LAKE PONTCHARTRAIN, LA. AND VICINITY
LAKE PONTCHARTRAIN BARRIER PLAN

DESIGN MEMORANDUM NO. 2, GENERAL
ADVANCE SUPPLEMENT
INNER HARBOR NAVIGATION CANAL WEST LEVEE
FLORIDA AVENUE TO IHNC LOCK

LMVED-TD (NOD 13 March 1967) 3d Ind
SUBJECT: Lake Pontchartrain, La. & Vicinity, Lake Pontchartrain Barrier
Plan, Design Memorandum No. 2 - General, Advance Supplement,
IHNC West Levee - IHNC Lock to Florida Avenue

ENGW-EZ (DSED-TP; 13 Mar 67) 2nd Ind
SUBJECT: Lake Pontchartrain, La. & Vicinity, Lake Pontchartrain Barrier
Plan, Design Memorandum No. 2 - General, Advance Supplement,
IHNC West Levee - IHNC Lock to Florida Avenue

PLATE III - 1

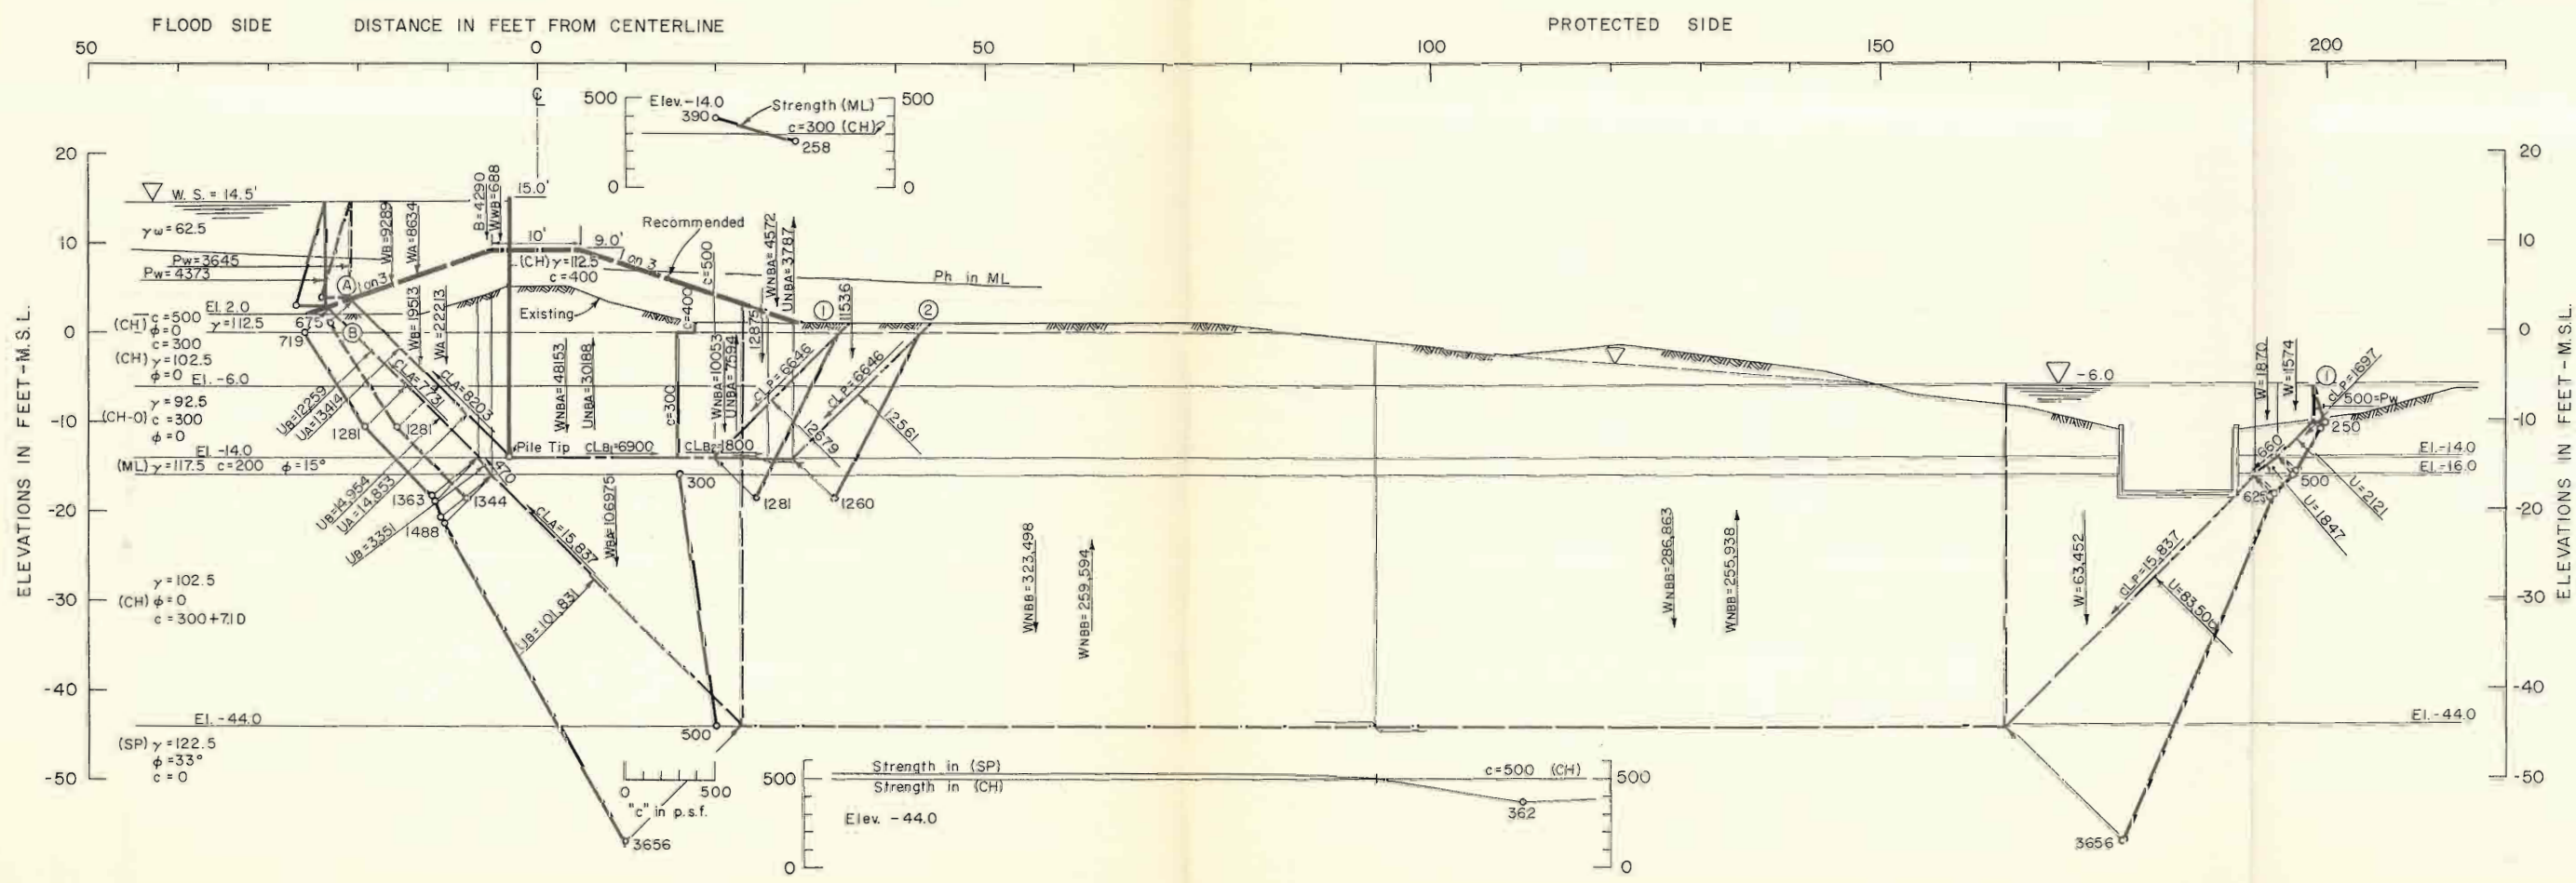
4. Section III, para 15, and plates III-2 and III-3. The boring logs in the vicinity of the leveed portion of the protection from sta 34+95 to sta 44+12 indicate a silt stratum varying from about el -14.0 to el -18.0. Since the line of protection in this reach is only about 180 feet from the Florida Avenue drainage canal, the bottom of sheet piles for this reach should be extended to about el -20.0 to cut off this stratum. In design studies for connecting the protection to the siphon at Florida Avenue, the possible presence of a relatively pervious stratum in the foundation that could lead to critical uplift pressures under the ditch paving should be considered.

Figure 4-33

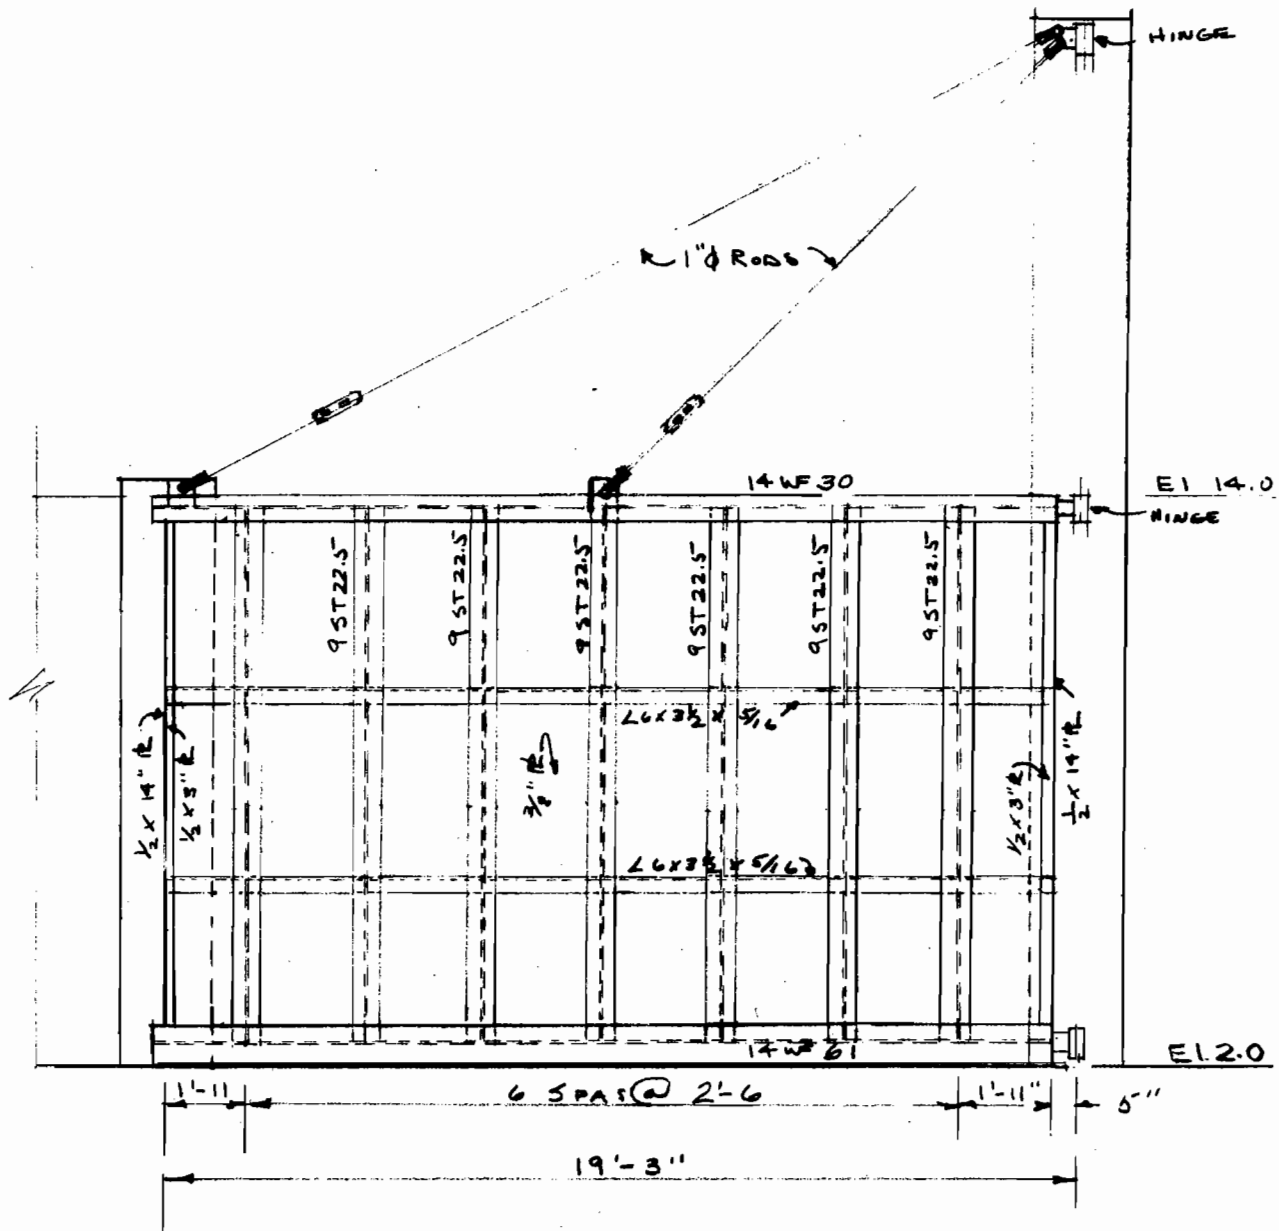
8. Figure 4-33. Consider eliminating the 1-inch tie rods and designing the hinges for the greater reactions.
